Technical Evaluation Report

REVIEW OF  
RESOLUTION OF KNOWN PROBLEMS  
IN ENGINE COMPONENTS  
FOR TRANSAMERICA DELAVAL INC.  
EMERGENCY DIESEL GENERATORS

December 1985

Project Title: Assessment of Diesel Engine  
Reliability/Operability

FIGURE 4.8.1. Torsional Vibratory Stresses for Single Orders in TDI DSRV-20-4 Crankshaft at Full Load

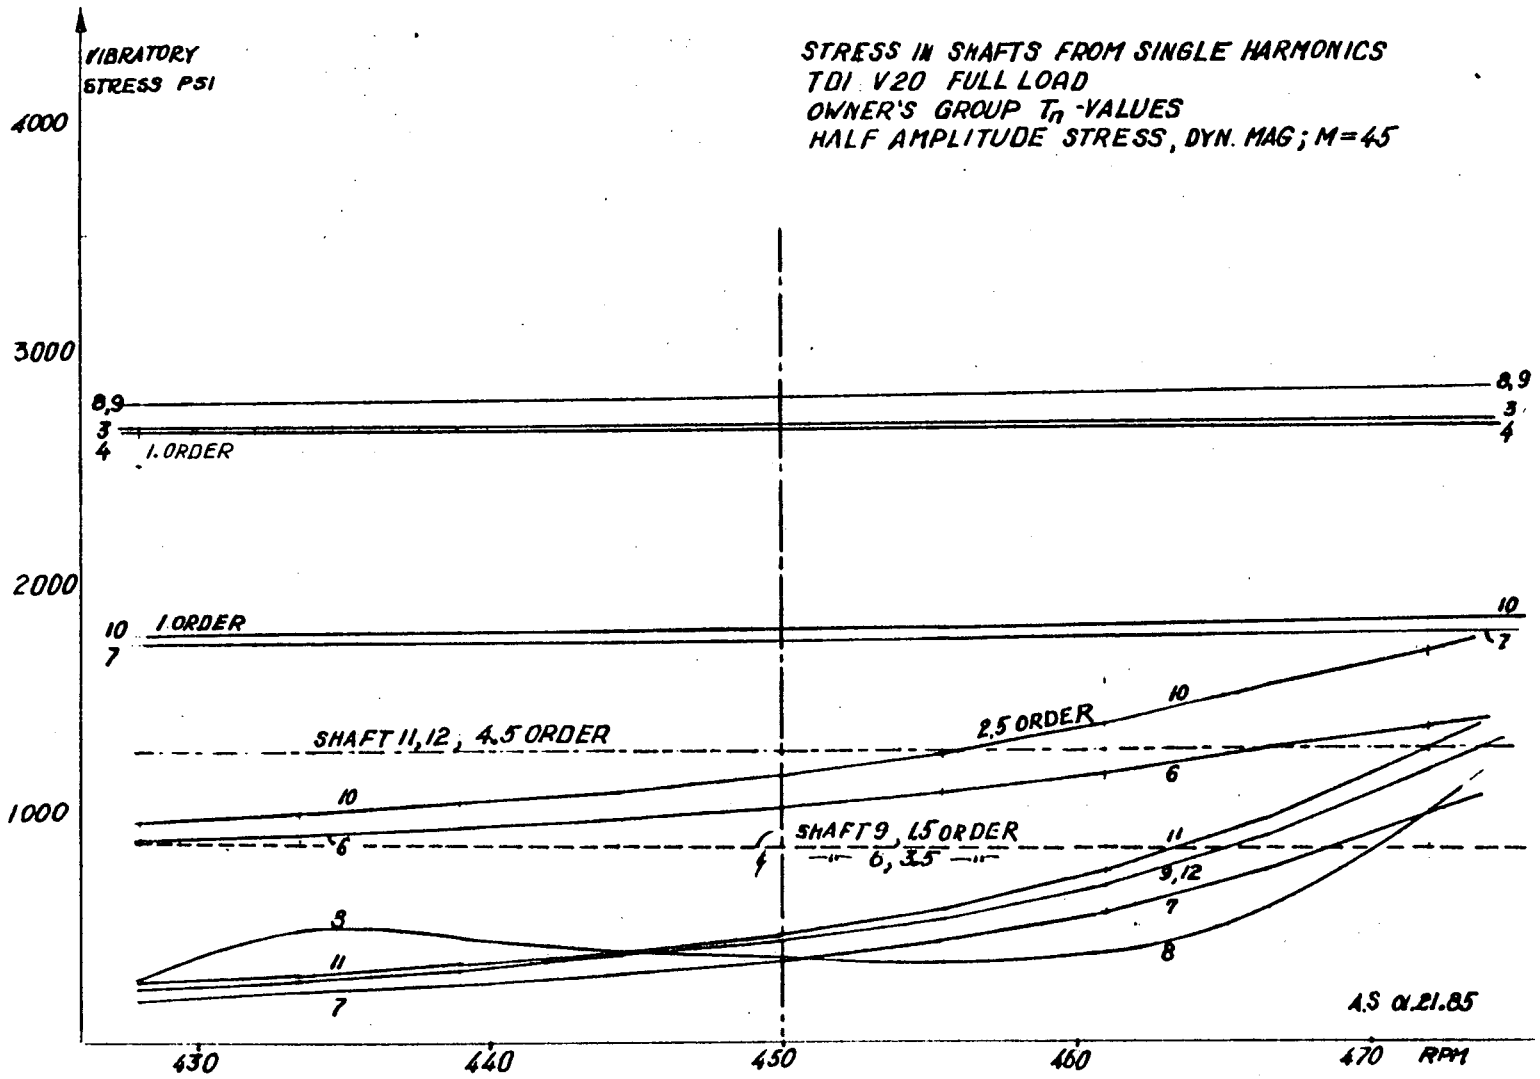
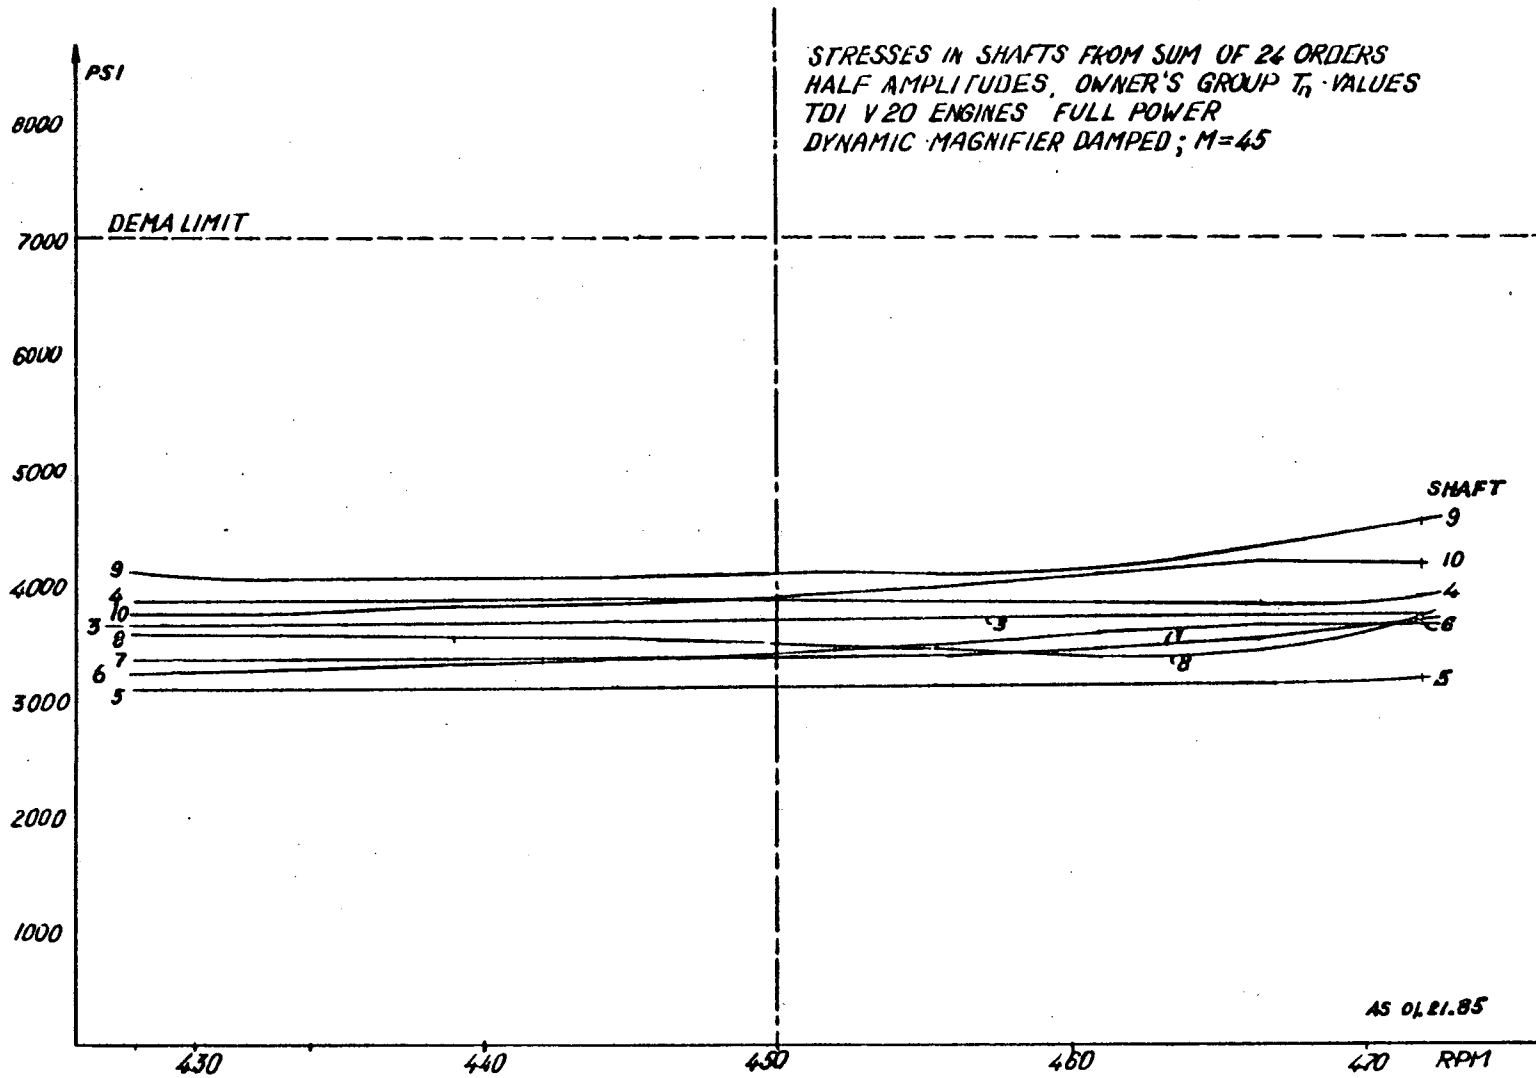
vibration. As shown in these figures, the maximum nominal torsional stresses for single orders and for the sum of 24 orders are 2800 psi and 4550 psi, respectively, and occur at 105% of rated speed. These values are well within the DEMA-recommended limits of 5000 psi for single orders and 7000 psi for combined orders. The dynamic magnifier cited in Figures 4.8.1 and 4.8.2 is a function of the assumed damping, the masses, and the associated natural frequency of the torsional system for first-mode vibration.

**FIGURE 4.8.3.** Variation of Free-End Crankshaft Vibration with Engine RPM for Sum of 24 orders in TDI DSRV-20-4 Crankshaft

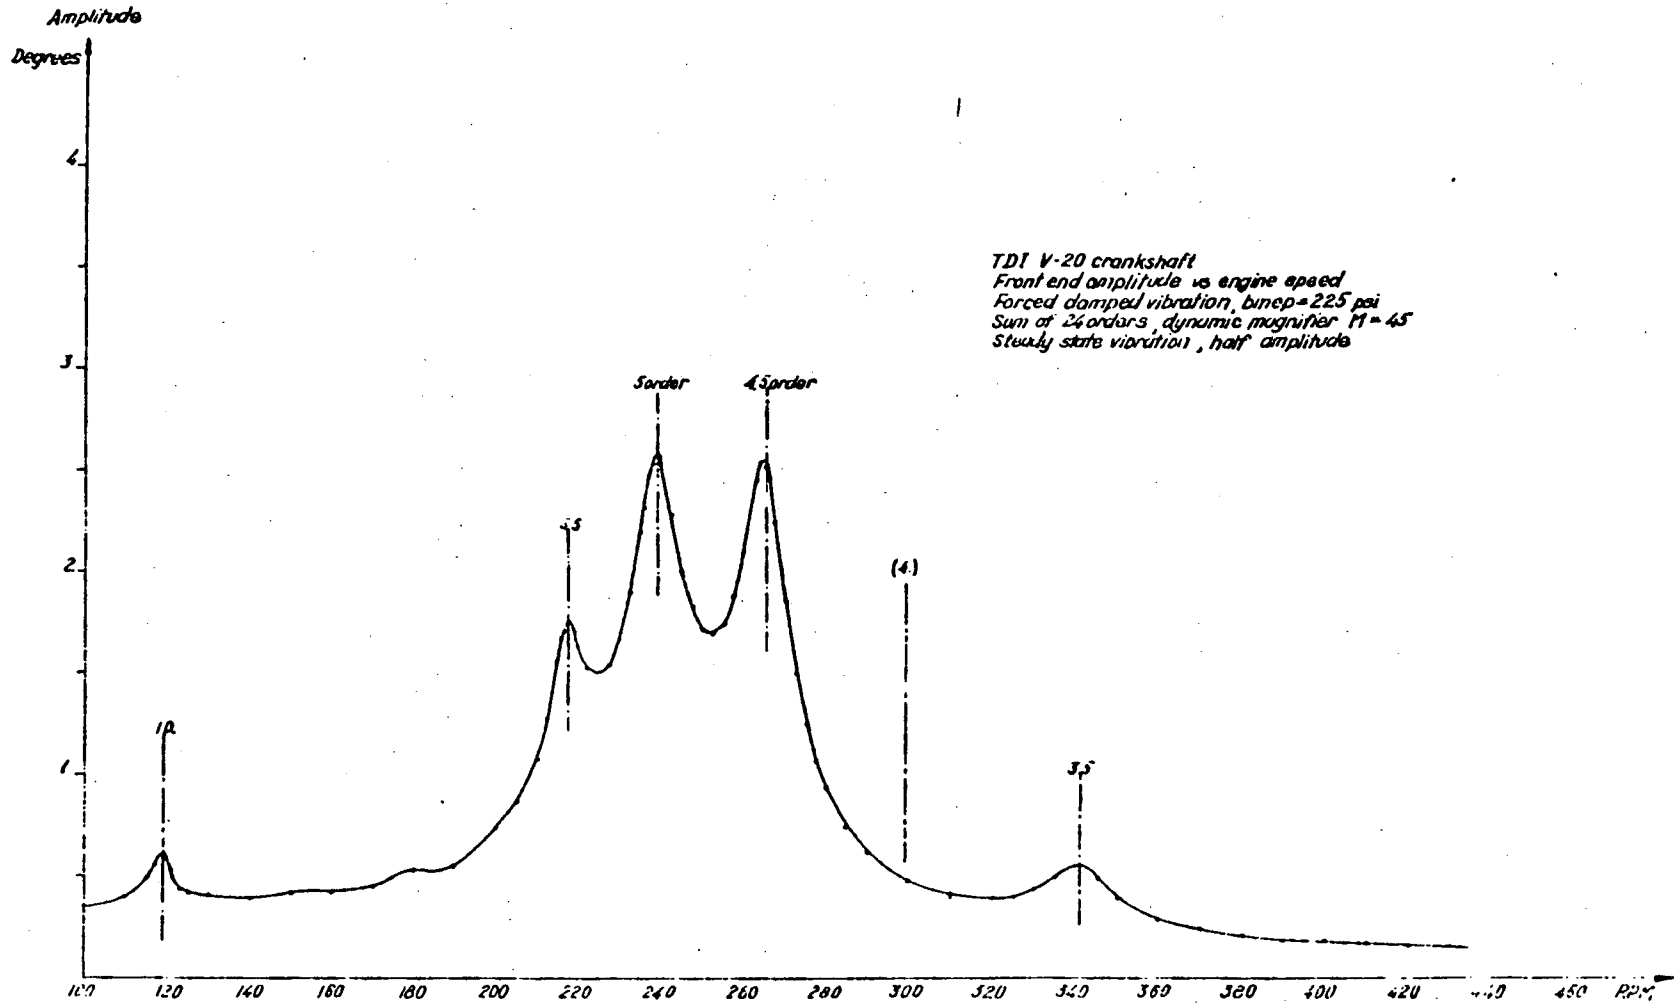
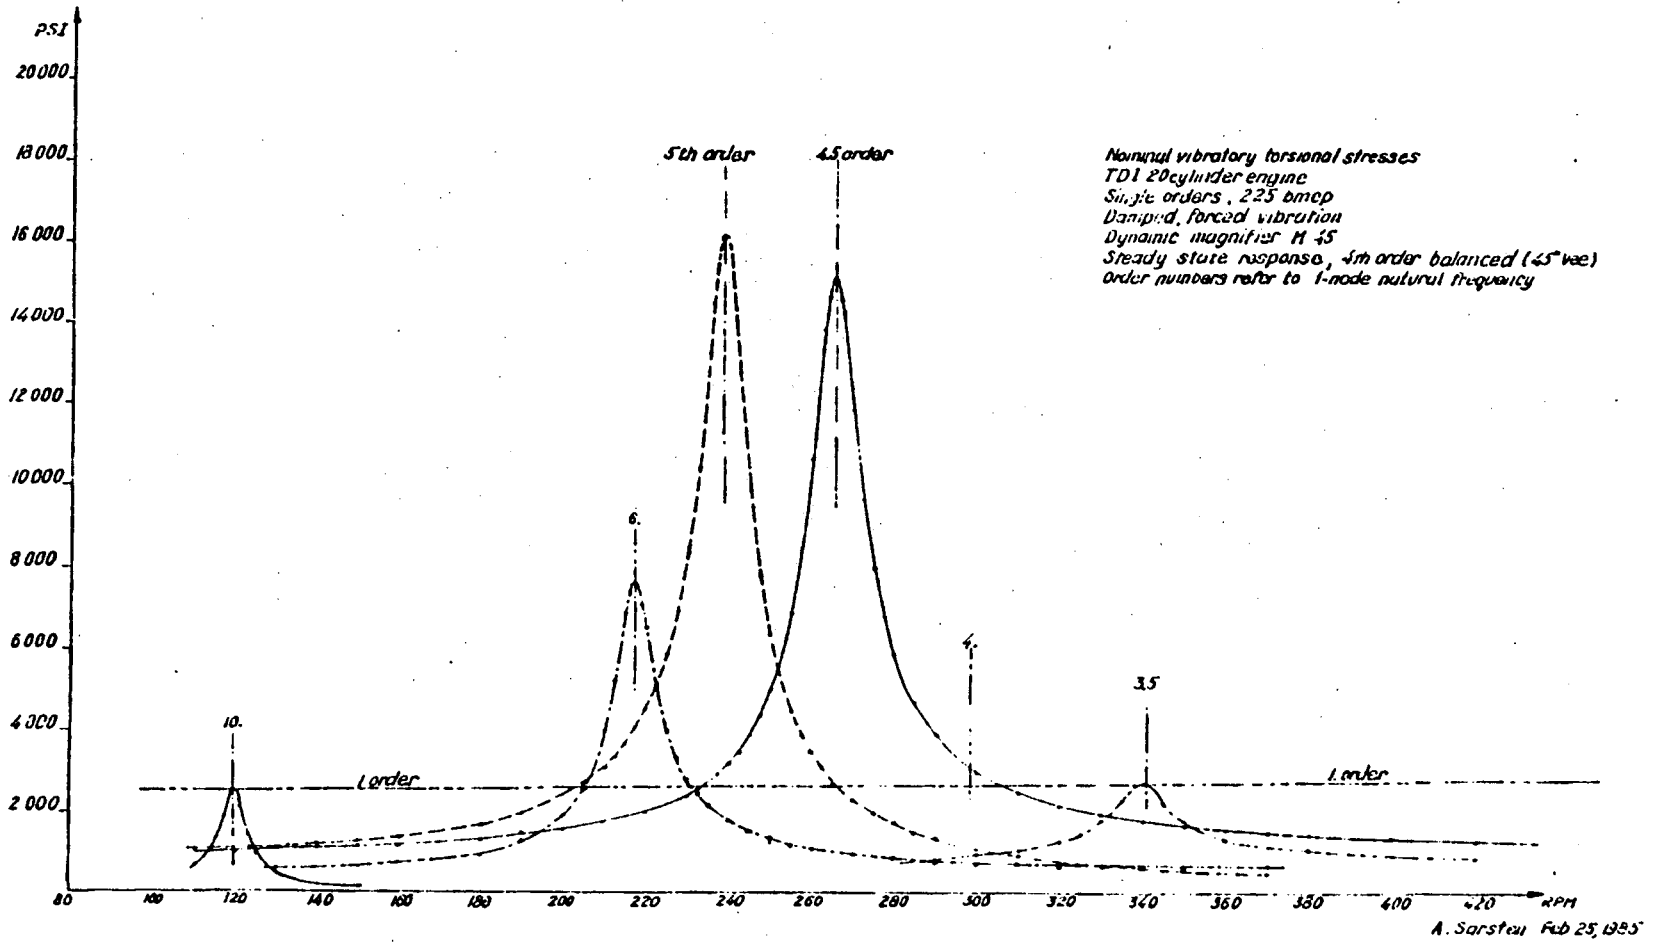
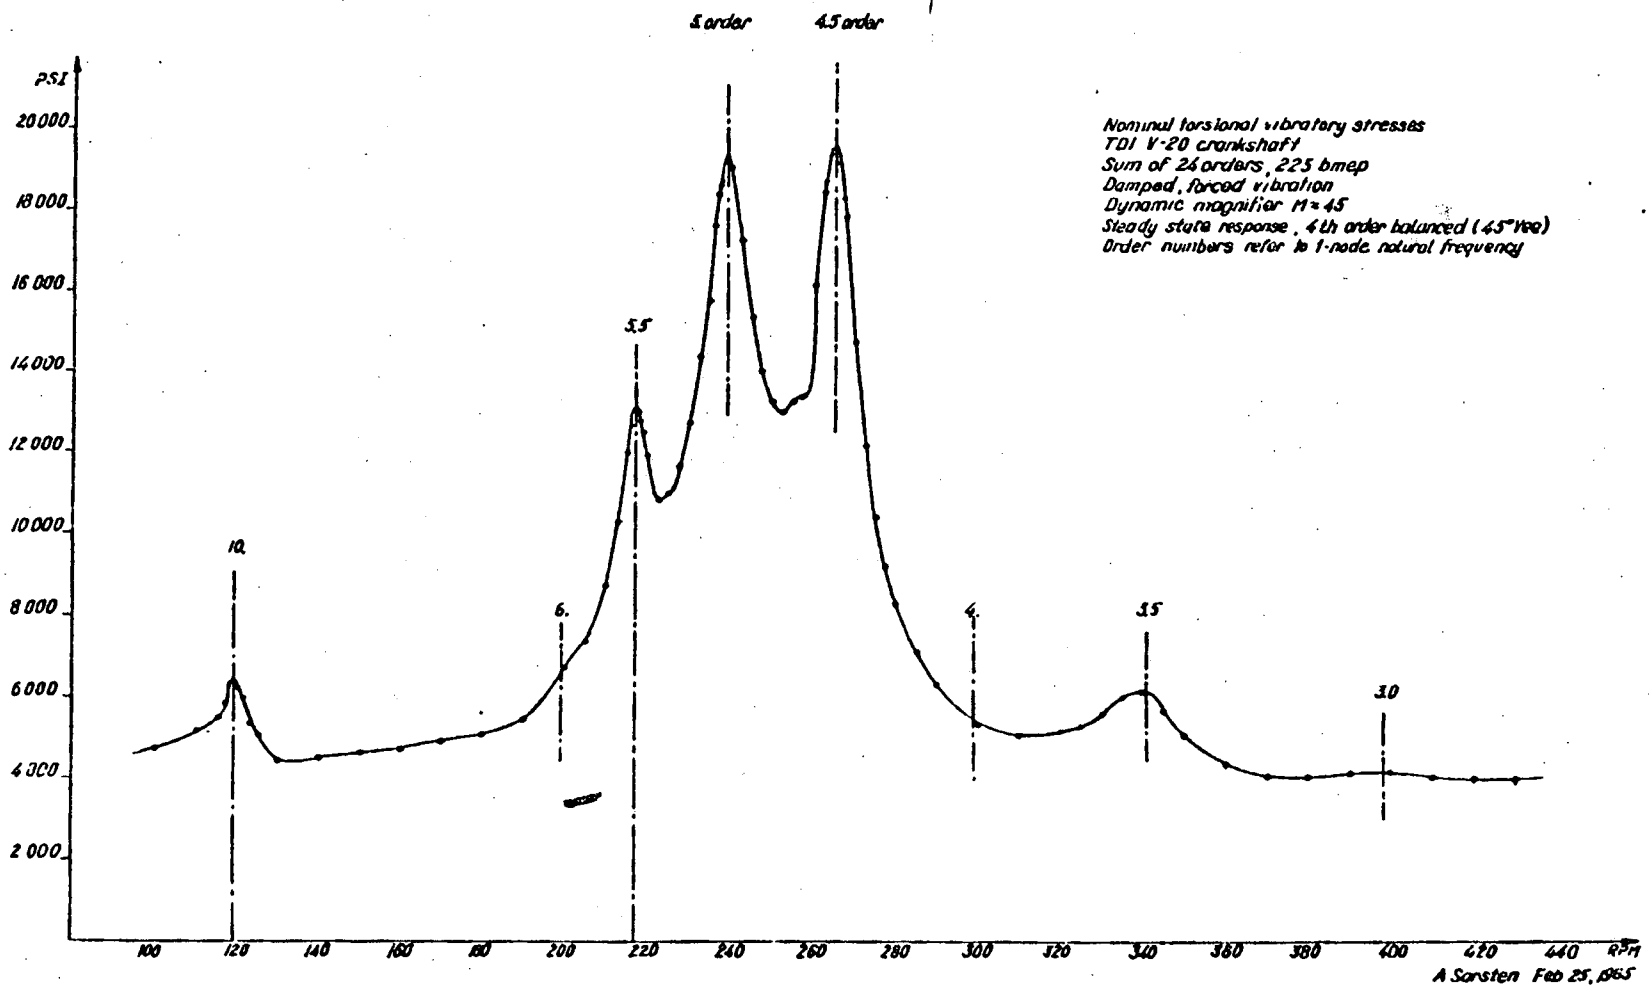
The results of Prof. Sarsten's analysis are summarized in Figures 4.8.3 through 4.8.5. Figure 4.8.3 shows the amplitude of free-end vibration of the crankshaft as a function of engine rpm. Figure 4.8.4 shows nominal torsional vibratory stresses for single orders of vibration, plotted as a function of engine rpm. Figure 4.8.5 shows nominal torsional vibratory stresses for the sum of 24 orders of vibration, also as a function of engine rpm. As noted earlier, the dynamic magnifier cited in these three graphs is a function of the assumed damping, the masses, and the associated natural frequency of the torsional system for first-mode vibration.

- A slow start would appear to be preferable to a fast start for accelerating through the criticals, for two reasons. First, the peak stresses would be shifted downward because the gas pressure loading would be lower. The advantage of lower stresses should outweigh the disadvantage of the increased number of cycles in the critical speed range. Second, the vibration initiated by one critical would be less likely to augment the vibration initiated by a neighboring critical.
- A transient torsional analysis or an experimental study would be required to quantify the possible benefits of slow starts. A transient analysis might also yield information on a starting position and possibly a speed sequence that would reduce crankshaft stresses when accelerating through the critical speed range.
